Amendments to the Drawings:

REMARKS/ARGUMENTS

Navy Case No. 83253

FIGURE 1

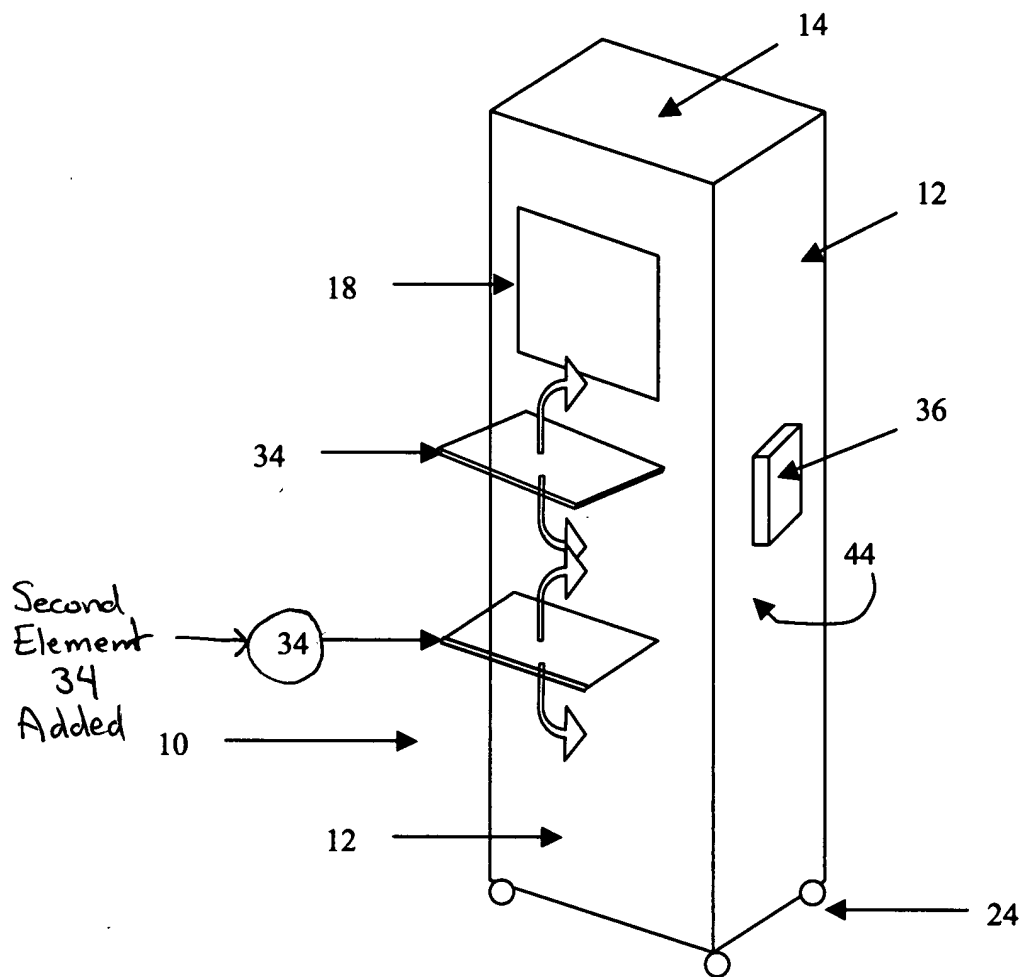
2. The Examiner had objected to the drawings under 37 C.F.R. 1.83(a) as not showing every feature of the invention as specified in Claim 19.

The attached sheet of drawings includes changes to Fig. 1. This sheet, which includes Fig. 1, replaces the original sheet including Fig.1. In Figure 1, previously omitted element 34 has been added showing “a plurality of shelves as claimed in Claim 19.” No new matter has been added.

Applicant has amended Figure 1 to include the limitation of Claim 19, which includes “a plurality of shelves coupled to said outer section of said walls to accommodate a keyboard for the CPU or other related items.” In amended Figure 1, previously omitted element 34 has been added. Applicant believes that no new matter has been added in the amendment of Figure 1. Replacement and annotated sheets of Figure 1 are attached to this response.
